AM Blocks Narrative regarding fourteen (14) drawings attached being modified with date 9-22-2020. These sheets are being modified to allow curvilinear Abernethy landward bonus plazas with expanded lawn that flows up to meet bonus plazas providing more welcoming spaces from the trails that are easily accessed by pedestrians. Reference drawing C.216 Subarea 3 that indicates that 80% of Subarea 3 is still being provided as required, that 60% of required landscape is planted in shrubs, and revised tabulation is provided for ground cover. These calculations are over minimum required. Exhibit C.219 indicates that to provide shrubs over required, some ground cover was reduced and some shrubs were increased. These two (2) above mentioned drawings can be compared to same drawings dated 6-22-2020. Drawing C.218 indicates that trees remain unchanged – this drawing has been re-submitted as Bonus area and maker's plaza have changed.

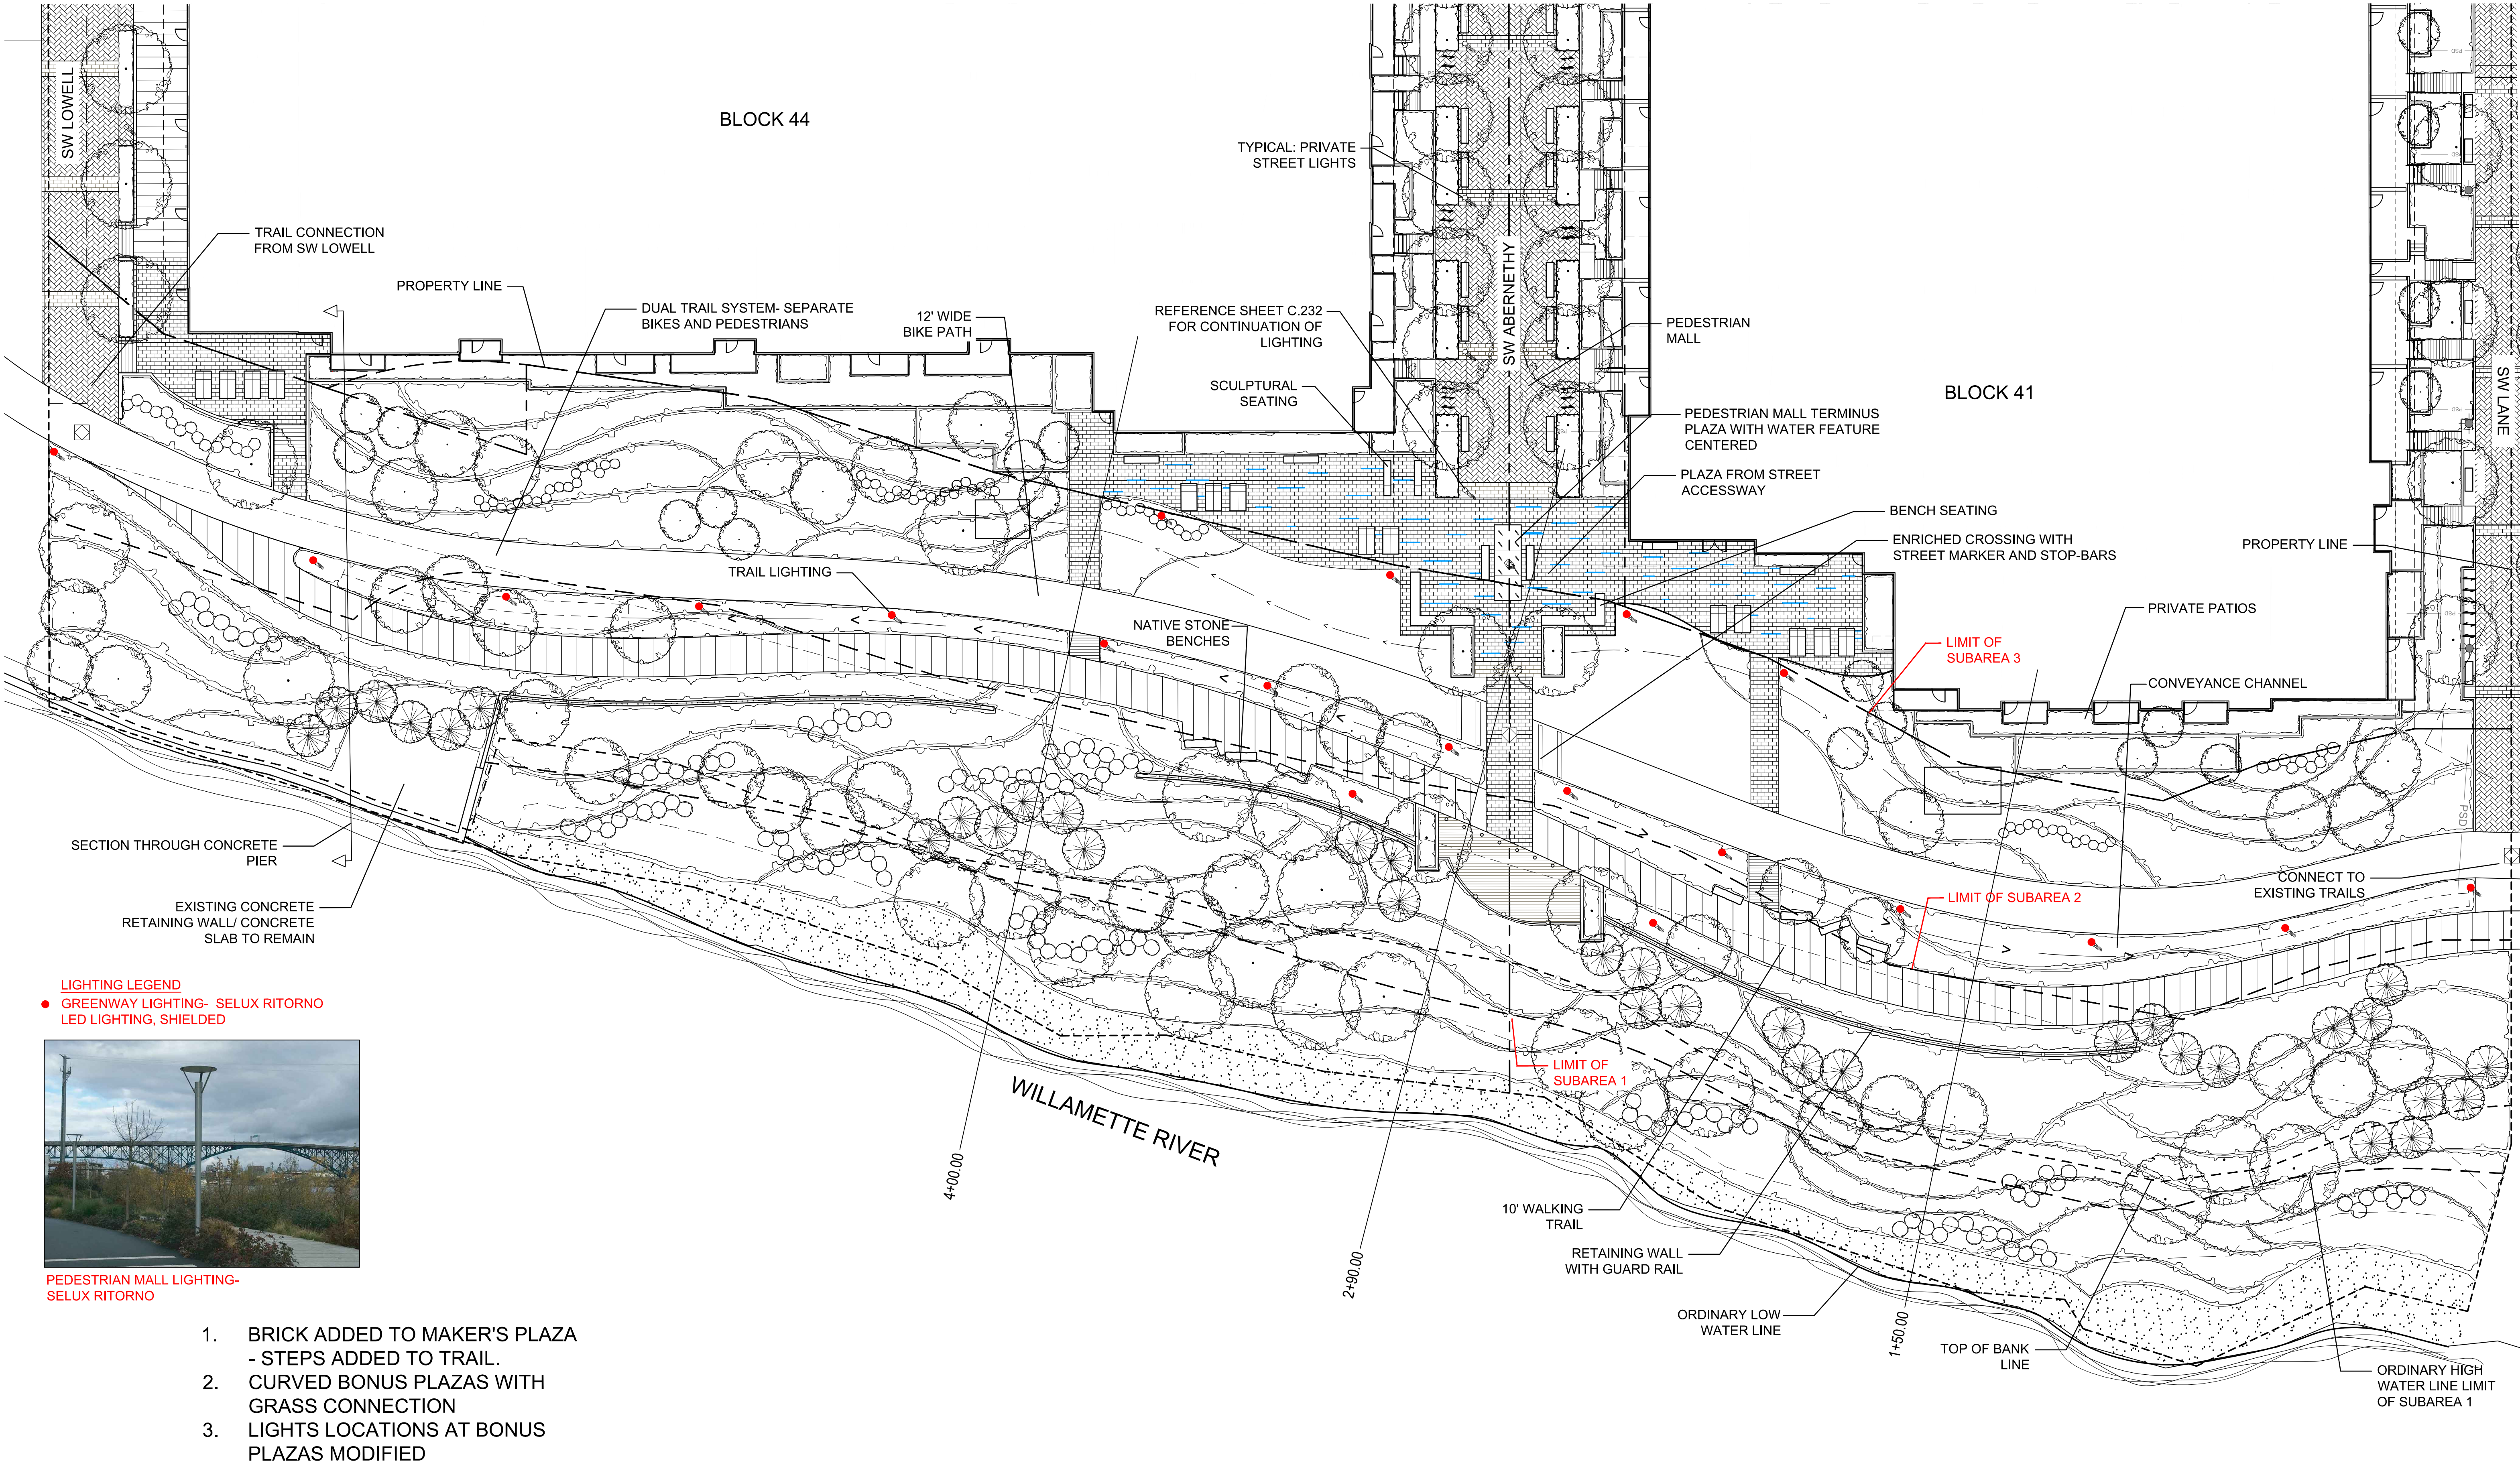
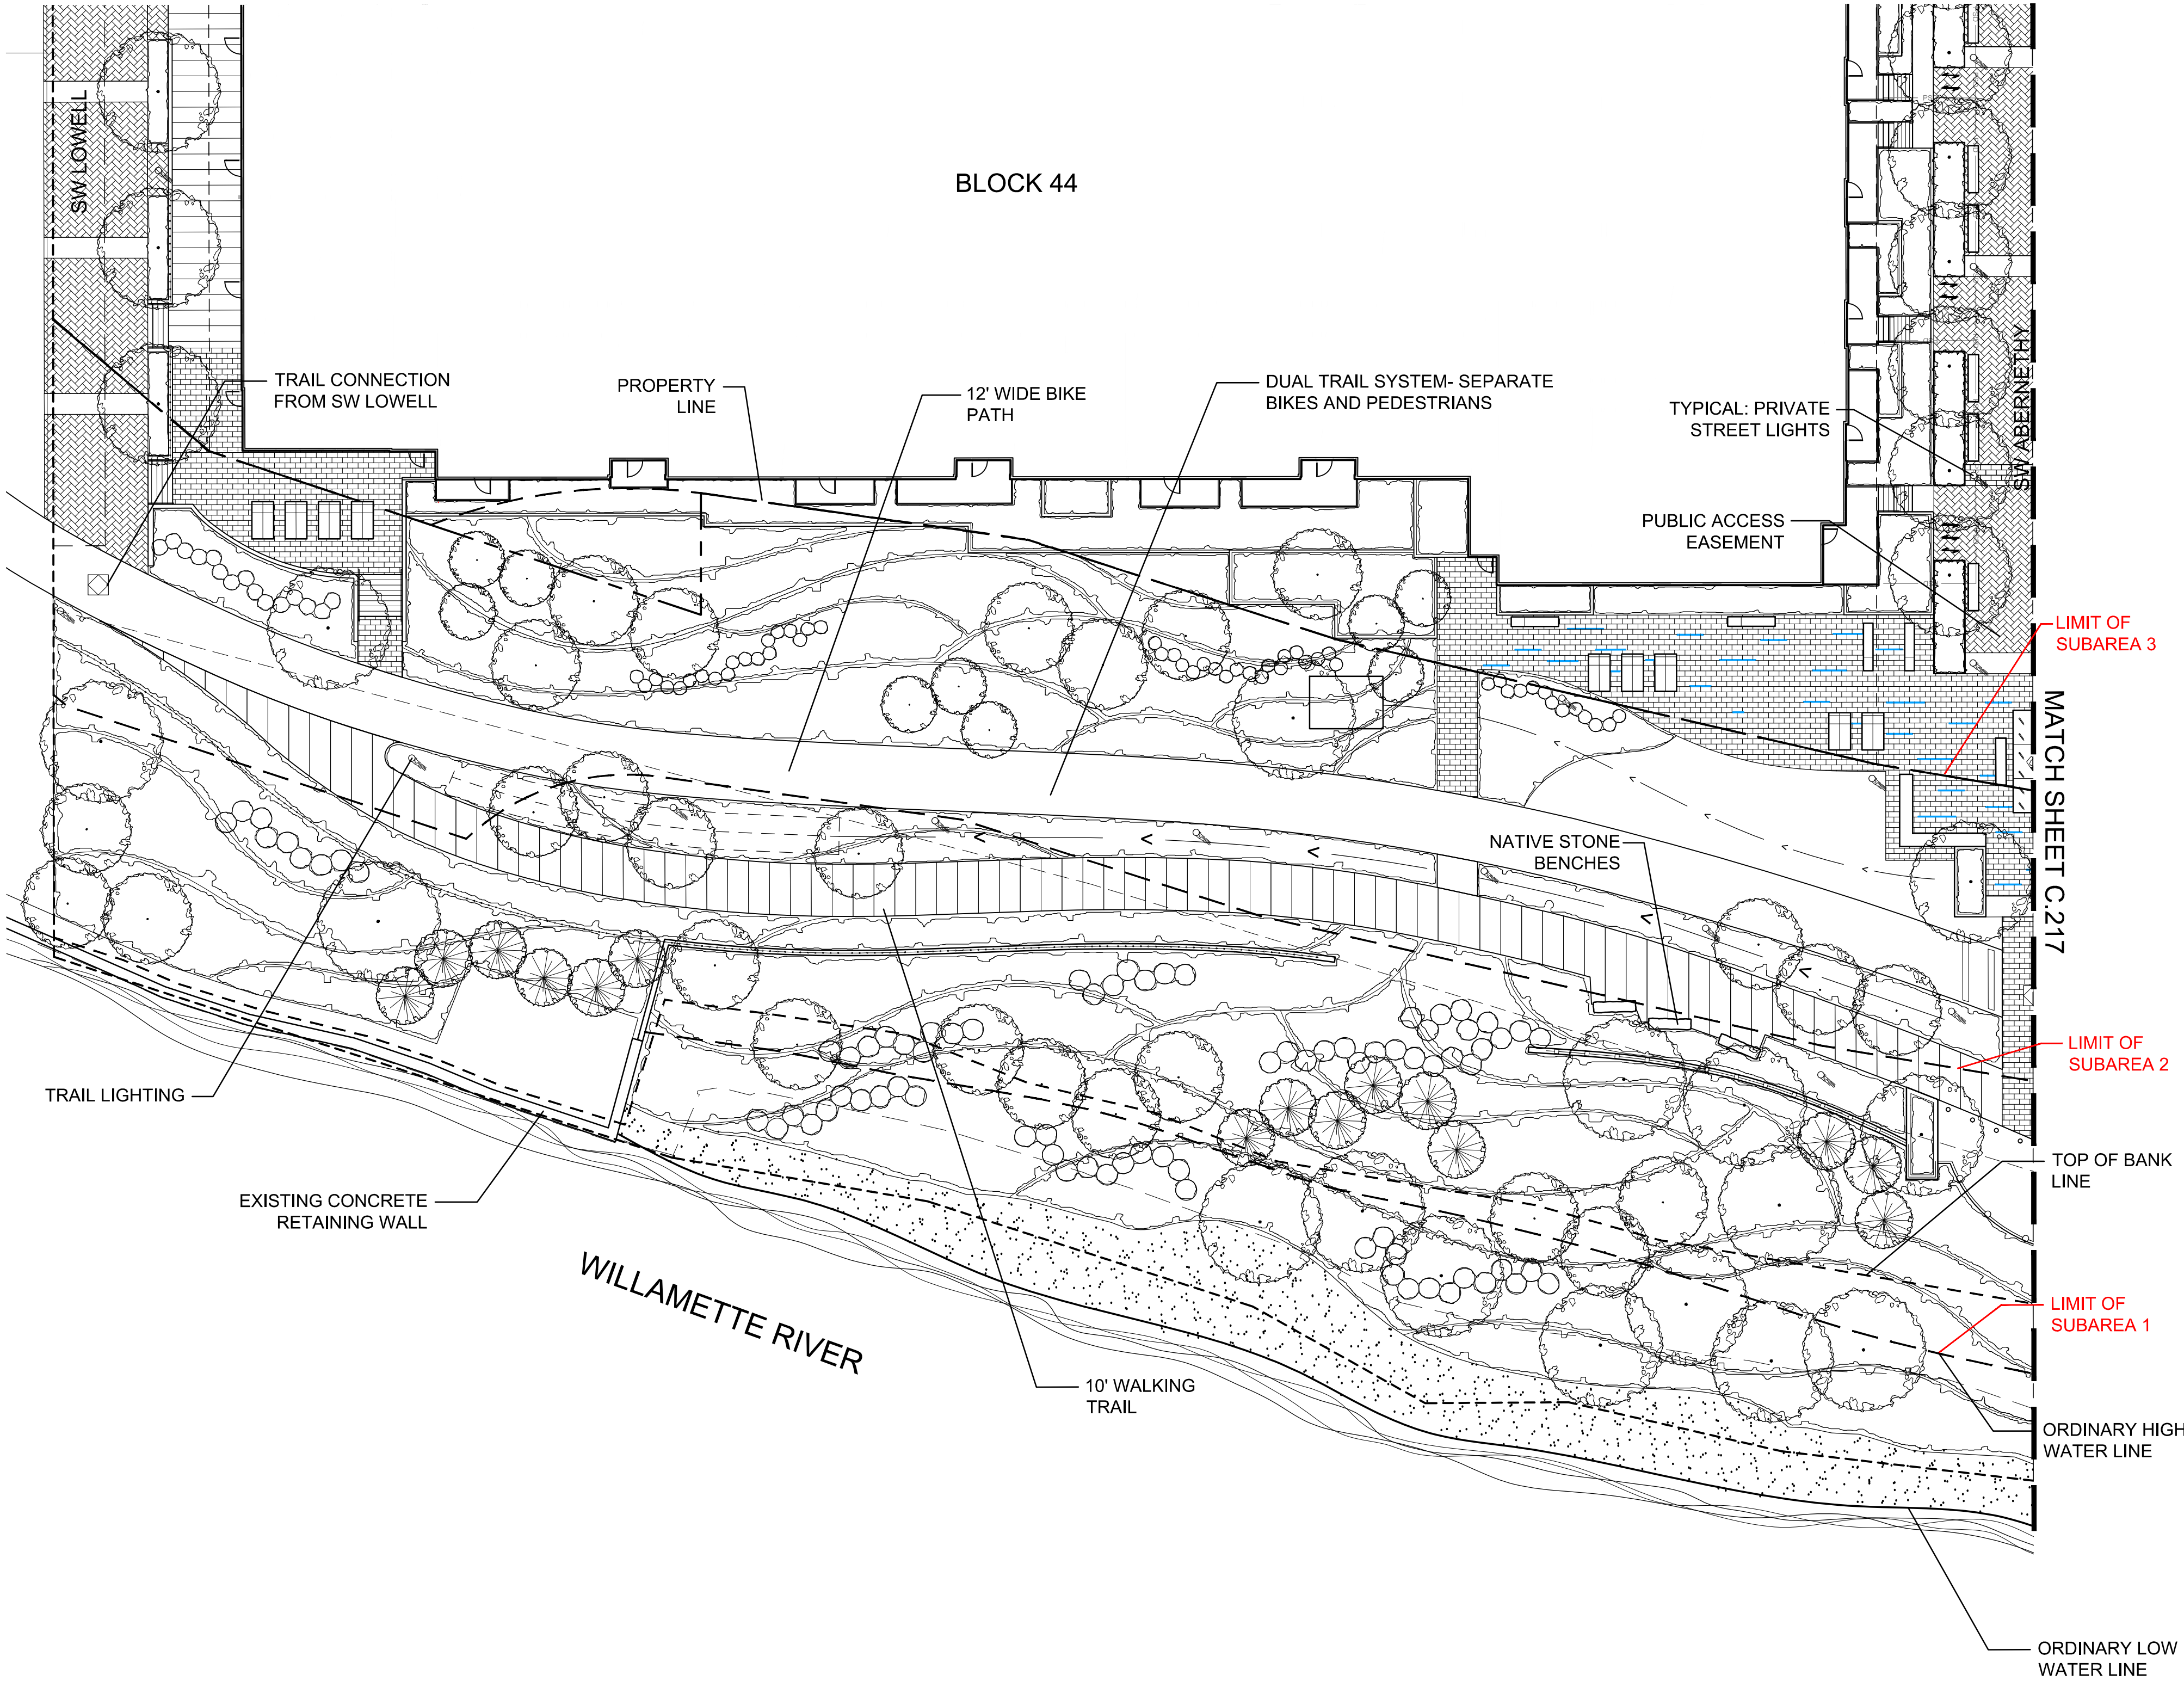
Several changes have been made to the Maker's Plaza. A set of steps to the east of the plaza provides direct connection to the trails. The Maker's plaza is all brick, including steps, and the low planter to the north of the plaza has been deleted. The grades to the east of the plaza have been adjusted so there is no longer a need for a guardrail providing a more open and welcoming plaza. In addition, the type of furniture has been changed to lounge chairs inviting public use.

- 1. BRICK ADDED TO MAKER'S PLAZA - STEPS ADDED TO TRAIL.
- 2. CURVED BONUS PLAZAS WITH GRASS CONNECTION
- 3. CHART MODIFIED

1. 80% of the area must be covered in shrubs or ground cover. 23,427 s.f. x 80%= 18,742 s.f. req. planting	20,627 s.f. planted area provided 18,926 sf (excluding lawn)

2. Shrubs. At least 60% of the required landscaped area must be planted in shrubs. At least 50% of the shrubs used to meet this requirement must be listed in the South Waterfront Greenway Subarea 2 and 3 Plant list. 19,251 s.f. x 60%= 11,245 s.f. shrubs	12,447 s.f. shrubs provided 11,866 sf

4. Ground cover. All of the required landscaped area that is not planted with shrubs must be fully covered with ground cover plants. At least 50% of the ground cover plants must be listed in the South Waterfront Greenway Subarea 2 and 3 Plant List.	0,100 s.f. groundcover provided on remaining area 7,060 sf
Plant list. 50% of required planting must utilize the South Waterfront Greenway Subarea 2 and 3 Plant List. Plants included on the Nuisance Plants List or Required Eradication List of the Portland Plant List are prohibited.	50% of the required planting within subarea 3 is from the Subarea 2 and 3 Plant List
